Architectural Review Committee Executive Summary

HEARING DATE: JANUARY 15, 2020

2017-013752COA

Project Address: 1772 VALLEJO ST Landmark: Landmark No. 31

PROPOSED 3RD FLOOR

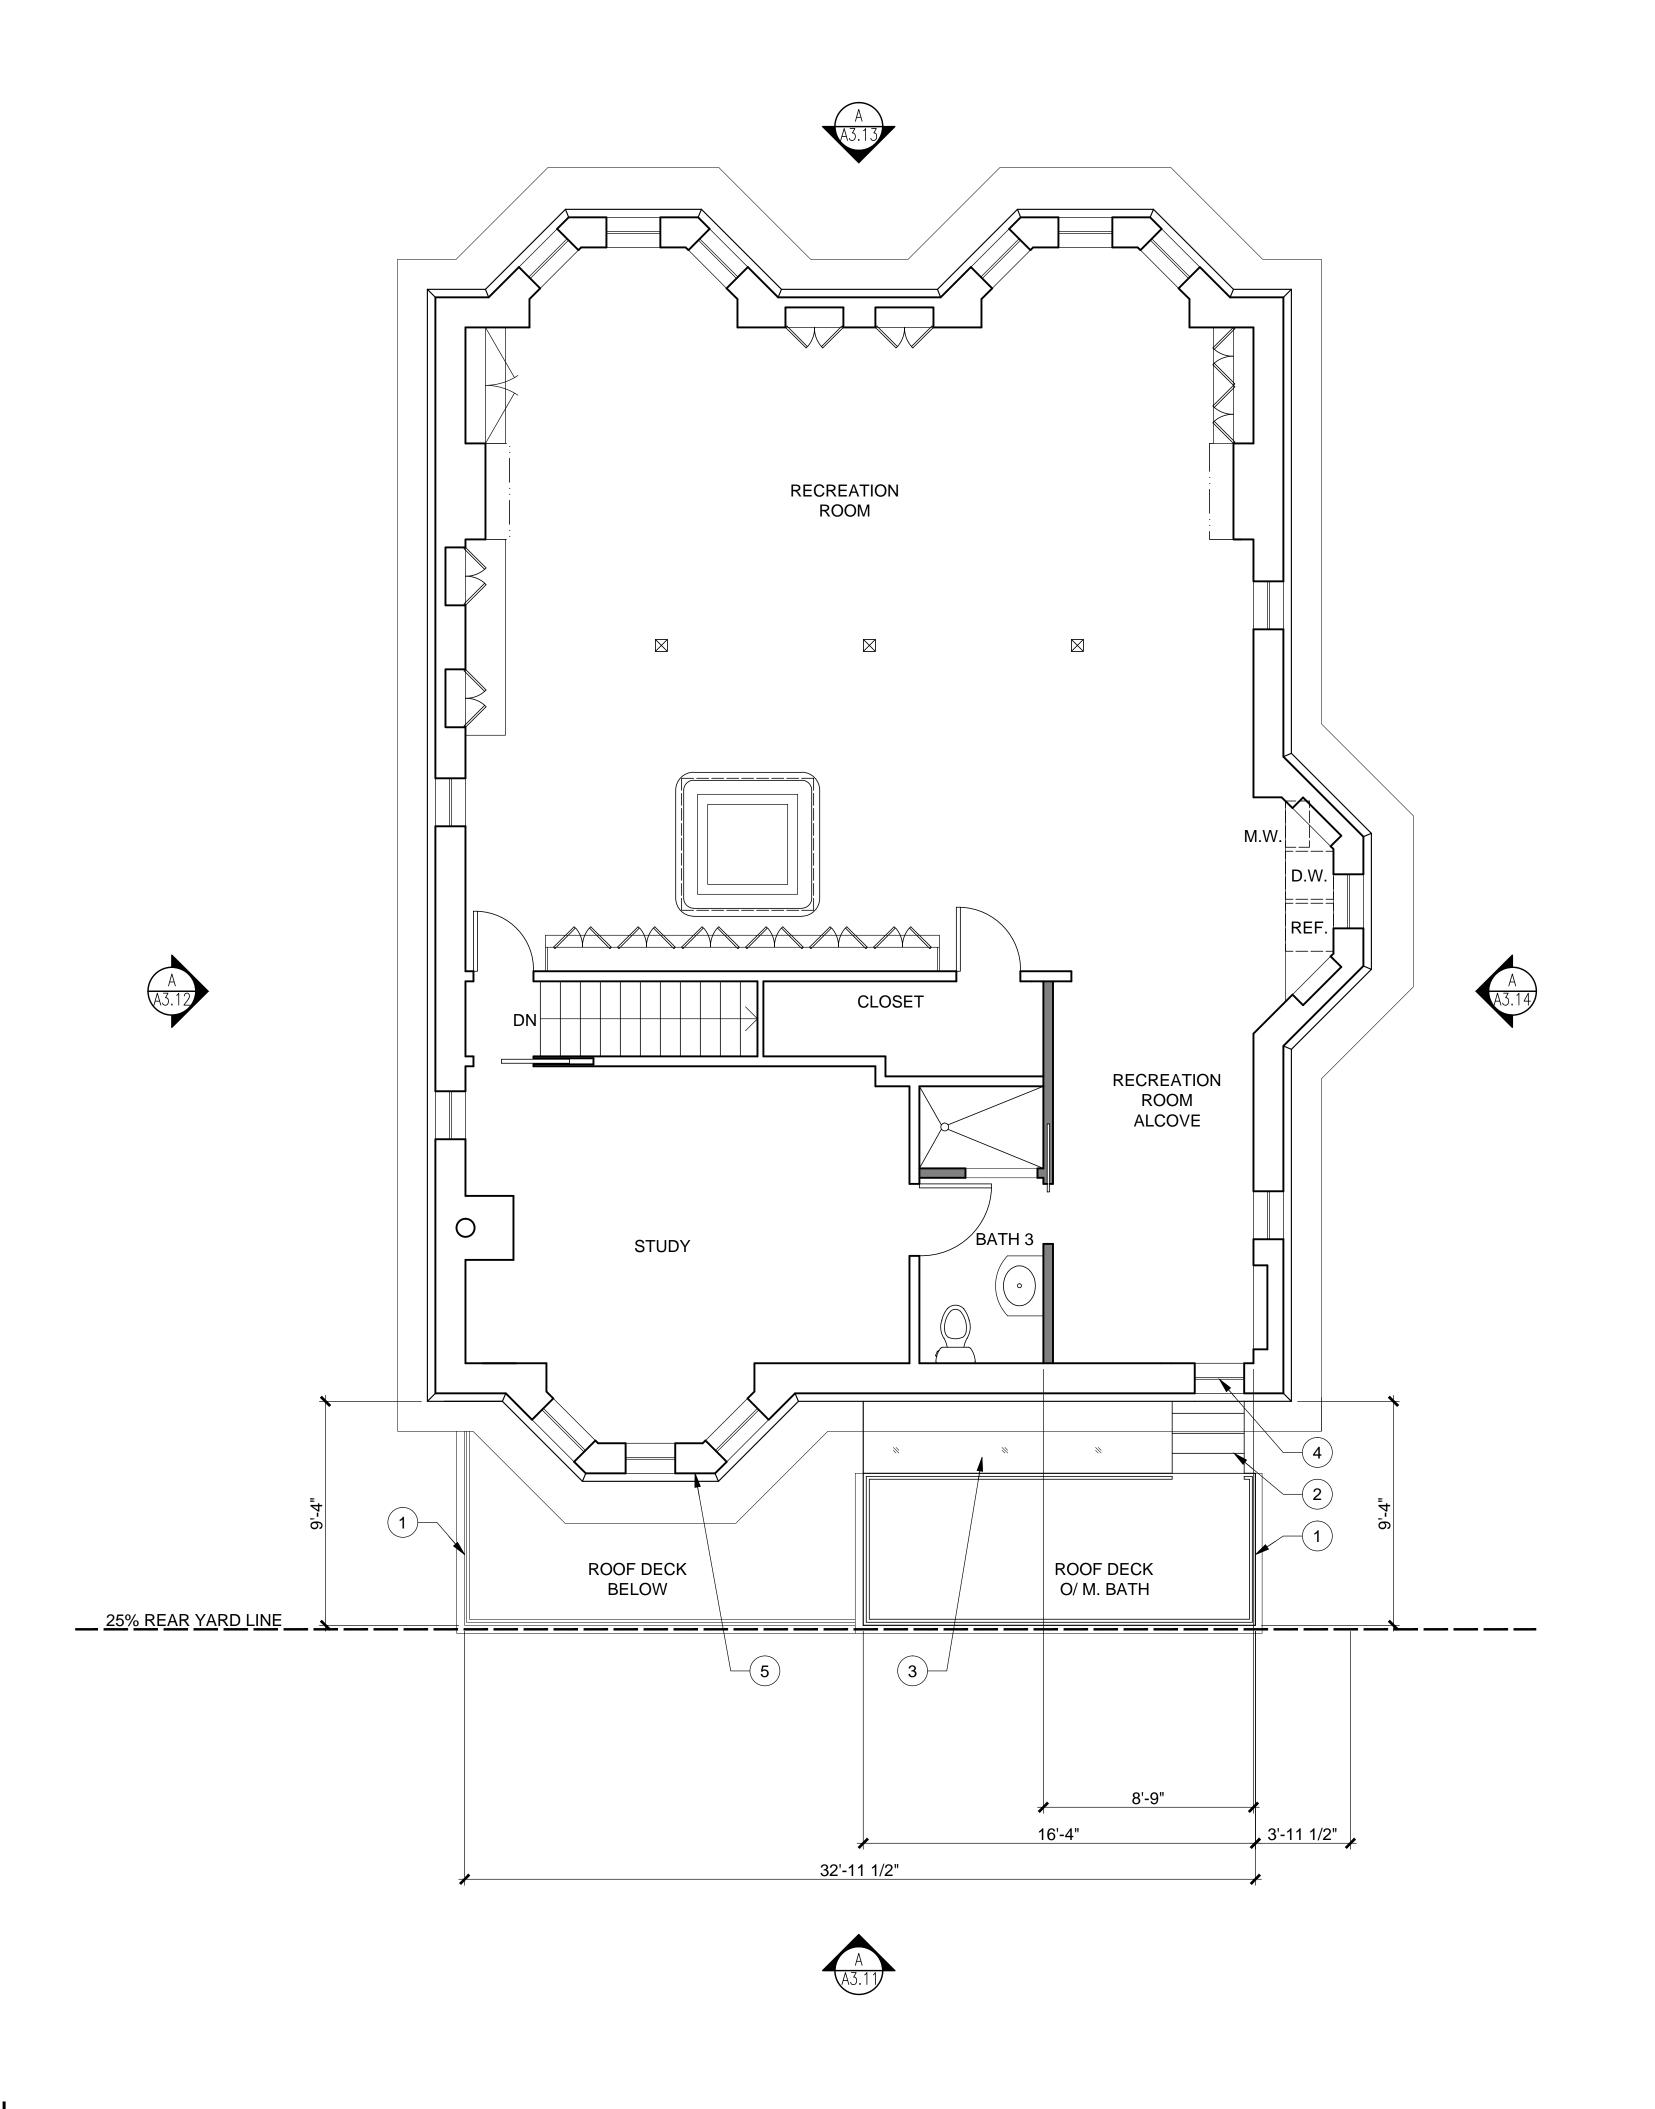
The addition will remove a substantial portion of the rear elevation. However, the first and second stories have been previously altered with an enclosed room, removal of an enclosed porch and alterations to windows. The third story portion of the addition removes two historic windows. Staff recommends retaining the westernmost window at the third story as the addition is proposed to be set in at this location. The addition appears to retain visibility of the historic quoining at the sides the house. The roof deck at the third story will be below the bay window, which appears to allow the historic features below the bay window to remain visible. Staff recommends eliminating the roof deck at the fourth story as it appears to impede visibility of the brackets below the mansard roof.

The addition appears to retain visibility of the historic quoining at the sides the house. The roof deck at the third story will be below the bay window, allowing the features below the bay window to remain visible. Staff recommends eliminating the roof deck at the fourth story to allow the brackets below the mansard roof to remain visible. Staff also recommends retaining the westernmost window at the second story in order to retain the distinctive hood molding and surround.

EXTERIOR ELEVATION

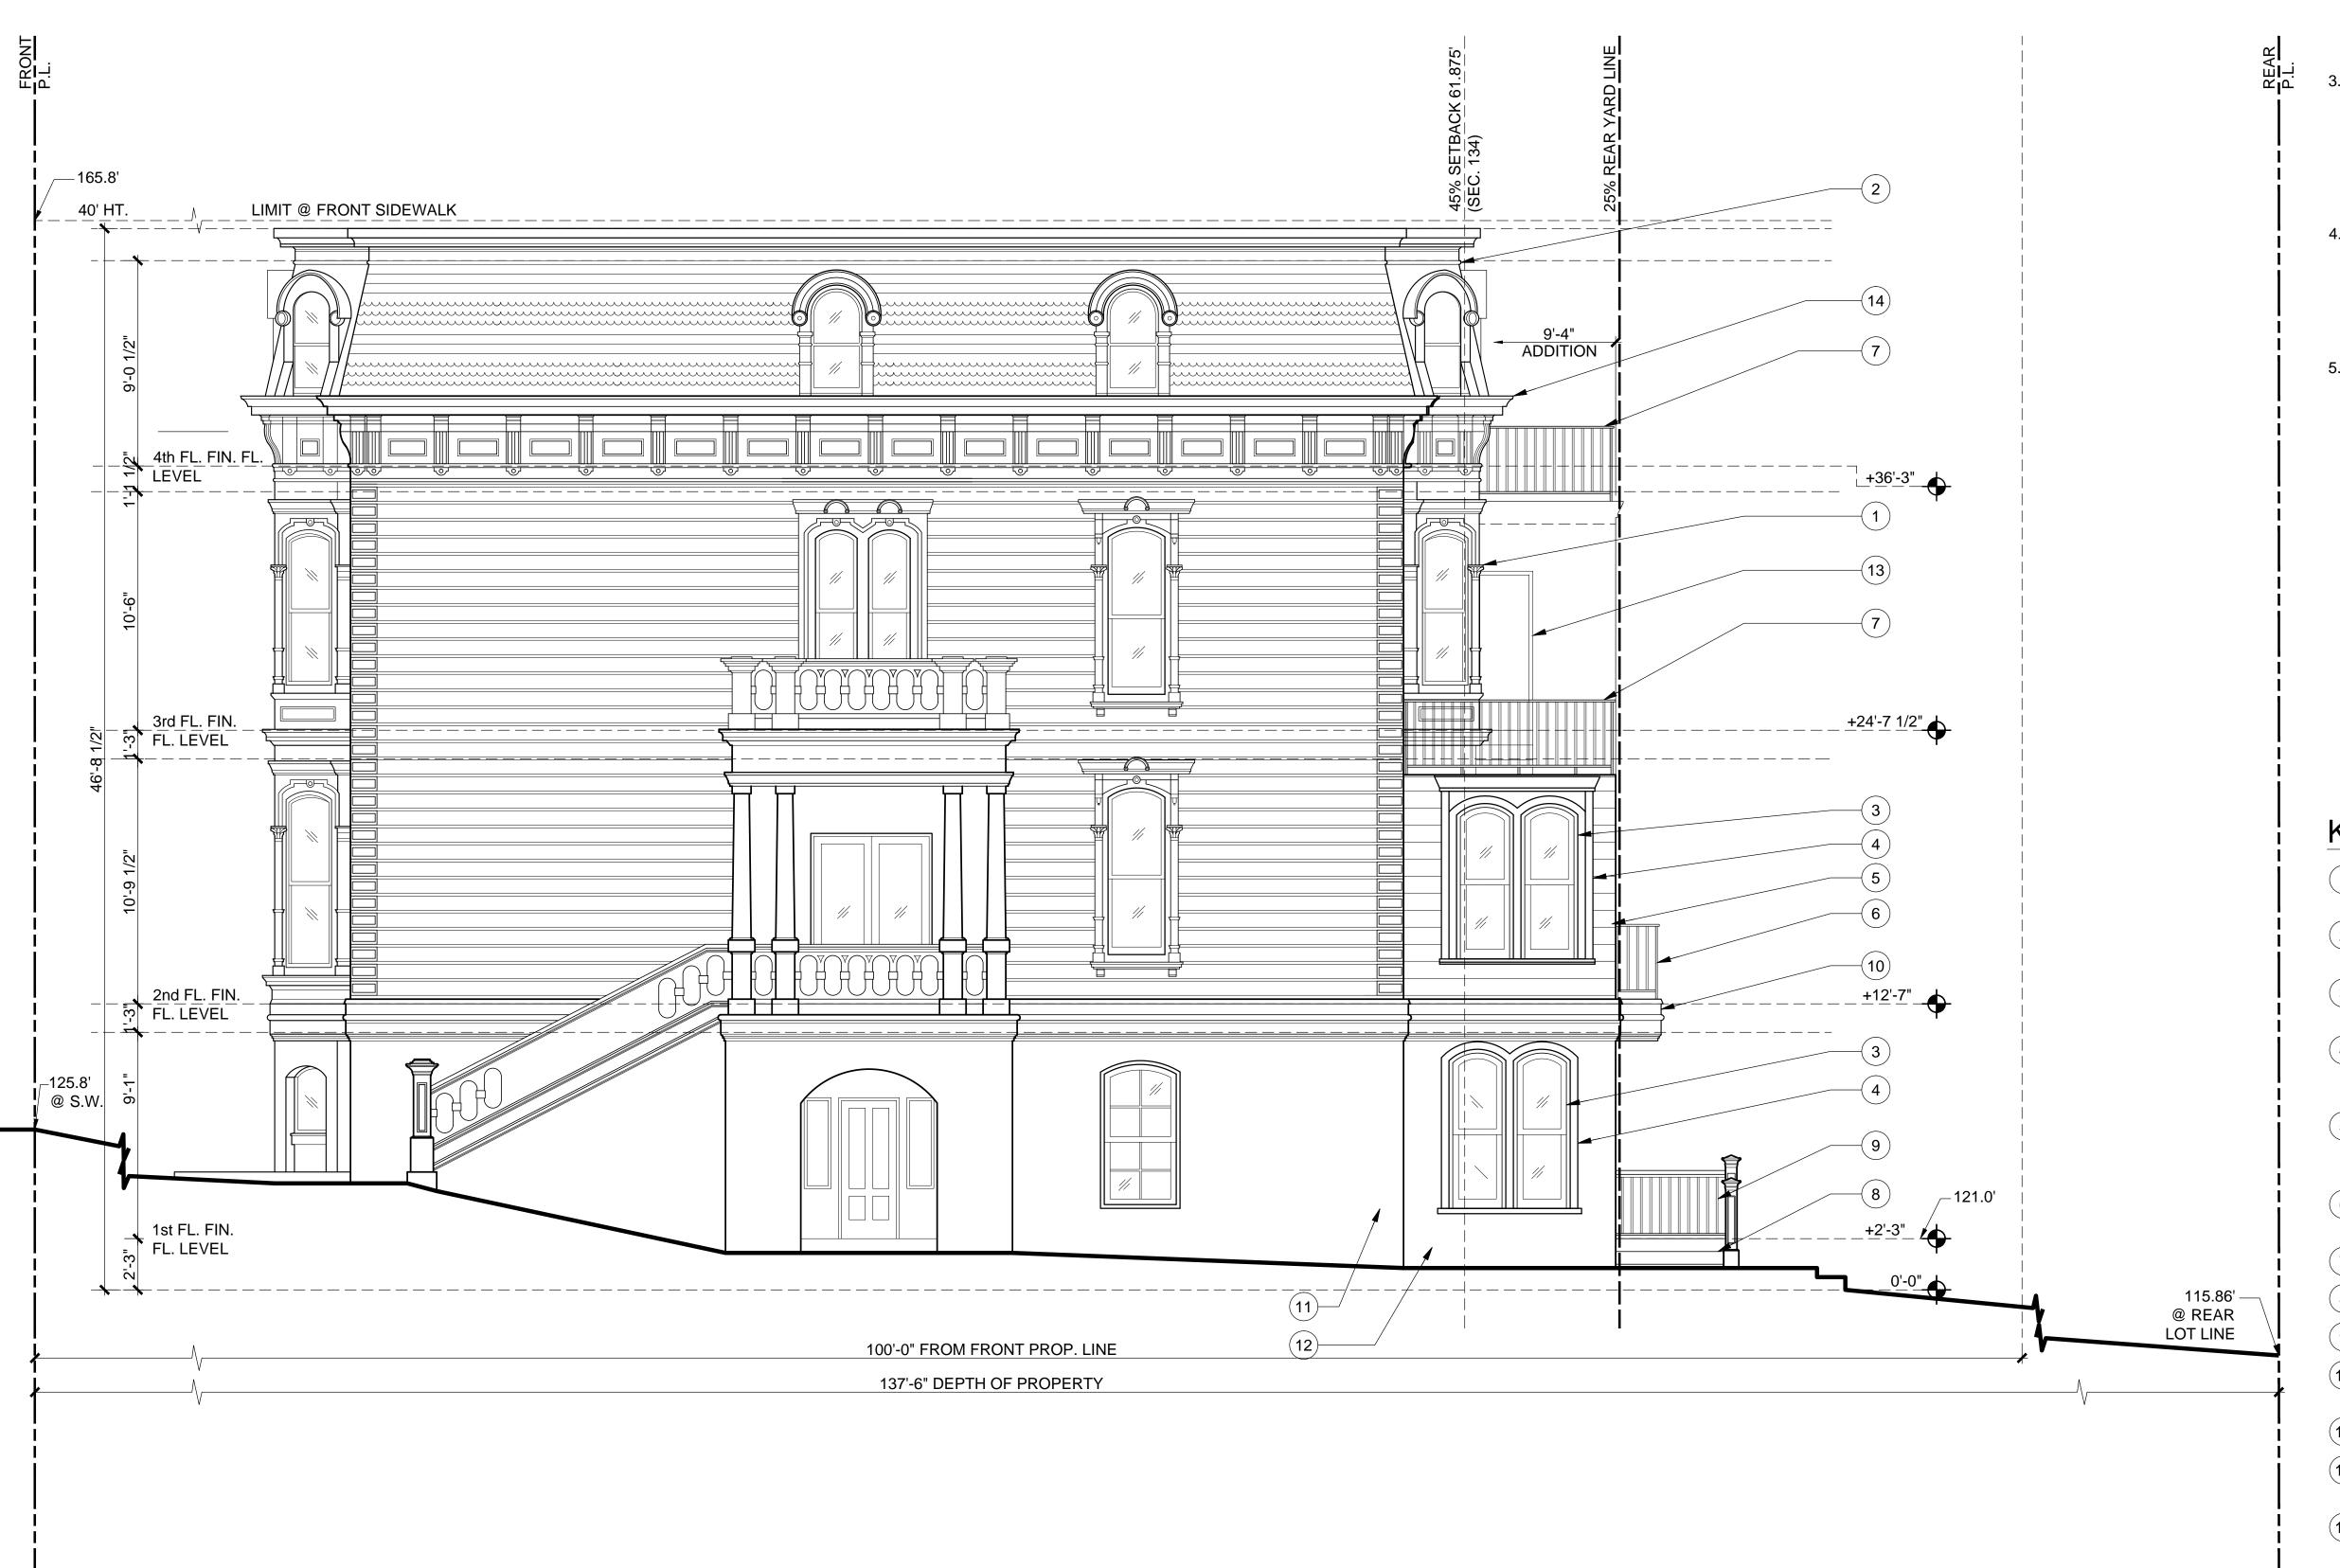
The balconettes at the first story and use of banks of arched windows throughout the addition appear to add conjectural architectural elements. Staff recommends eliminating the balconettes and using single windows with arched heads.

The massing, size and scale of the new addition appears to be compatible with the main house. However, architectural features such as banks of arched windows, rectangular window at the east elevation of the addition, balconettes, and metal railings at balconettes and roof decks do not appear compatible with the character of the property. Staff recommends individual arched windows, eliminating the balconettes and fourth story roof deck, and using wood railings at the third story roof deck.
